Title: BRS-5 Rockets

Bulletin ID: 002

ROCKET ASSEMBLY INSTRUCTIONS OVERLOOKED

REASSEMBLY, ROCKET LANYARDS AND CAP 9/95 Rev B 7/99 DRWG. 175-A

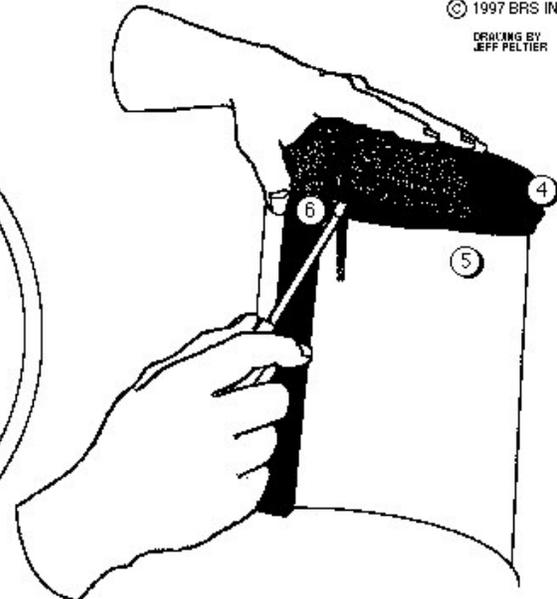
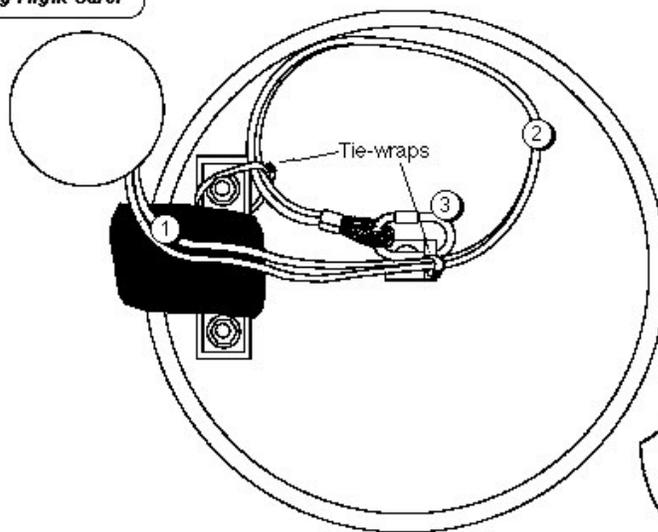
Firstly, some customers have used the silicone adhesive provided for another purpose to glue on the outer cap of the canister system. The units have an inner and outer cap. The inner one is permanently glued on at the factory and breaks away if the BRS unit is deployed. The outer cap, however, must not be attached except to snap it over the inner cap (as shown in the owners manual). If this outer cap is glued on, the system cannot perform as designed and a failed deployment is possible. Some customers feel motivated to glue this cap on as the amount of silicone adhesive provided by BRS is much more than needed (tubes of the adhesive are not available in smaller quantities). Other customers may recall older BRS units which sometimes had their cap come loose. In no event should customers glue on the new outer cap, nor should they secure older model caps with tape or additional adhesives.

Secondly, some customers have incorrectly attached the rocket lanyards (two small Teflon-sheathed steel cables which lead from the rocket to the parachute). These lanyards must connect to a small L bracket fastened to the inner cap. They should not be connected to large link attached to a heavy bridle on the outside of the canister. Ignoring this instruction will cause a failed deployment.

- ① Route rocket lanyards over top of riser extension and between clamp bolts.
- ② Carefully coil lanyards and lay them in place so that they don't tend to want to push the cap up. They may held in place with 1/8" wide tie-wraps.
- ③ Connect lanyards to small Quicklink. Apply Loctite 242 (blue) to threads on link and close barrel.
- ④ Re-install cap starting from the opposite side of the riser relief bump, working your way evenly forward along both sides of can.

- ⑤ While applying even downward pressure, ensure that the rim of the outer cap seats securely under the rim of the inner cap.
- ⑥ It may be necessary to use a flat, blunt tool (small screwdriver) to pull out the corners near the riser relief bump to allow them to slip down over the inner cap.
- ⑦ **Warning!** Do not glue or tape the outer cap in position! Doing will cause the unit to malfunction.
